RE: Valley Vista lot proposed changes

FW: Questions for the Committee tomorrow re 4474 & 4490 Valley Vista

RE: Questions concerning 4474 E. Valley Vista Lot Split

Drainage in middle of island lot.JPG ×

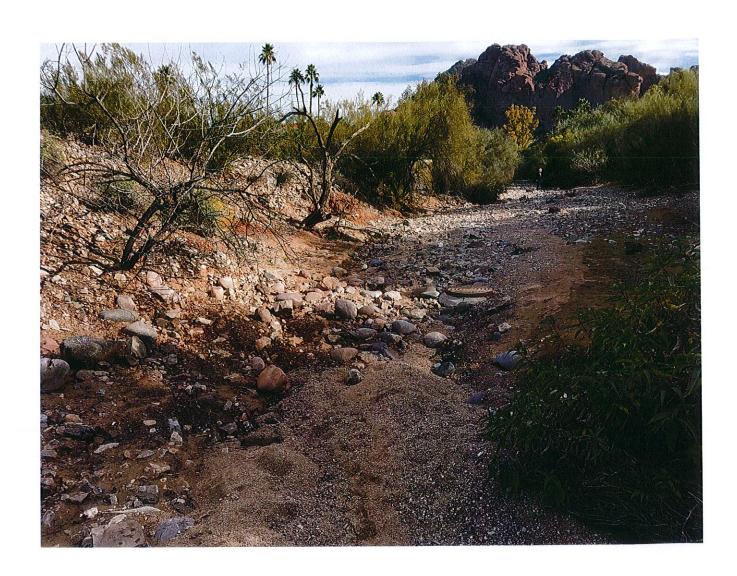
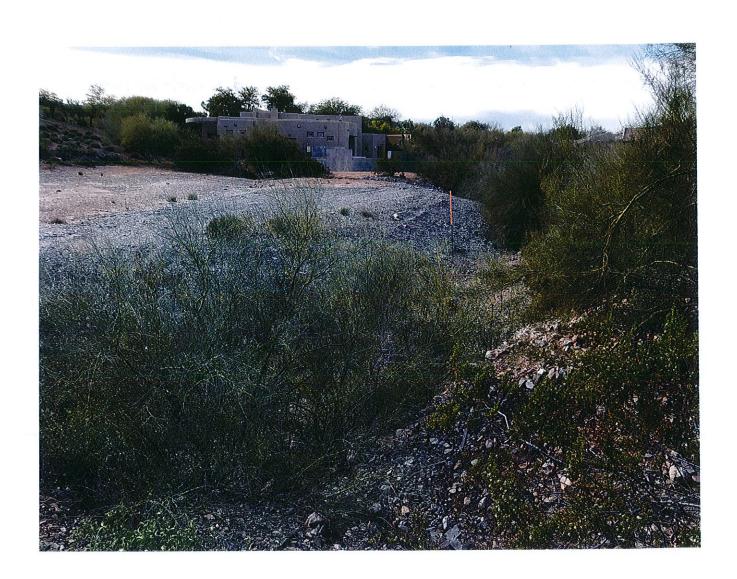
I am attaching photos taken on the island lot that is being considered for development and from the arroyo that divides the two properties on which the developer wishes to build. The photos show how much water/wash goes through the middle of the island lot to the degree it is creating a third arroyo. This third arroyo was not represented at all in the renderings. The main source of this water is through our property. Attached is a google earth picture that clearly shows the third arroyo.

Included also are pictures of the arroyo between the properties in question showing how deep and wide it is. The bridge and waterway are fancifully under represented in the renderings. I have attached the renderings for comparison purposes.
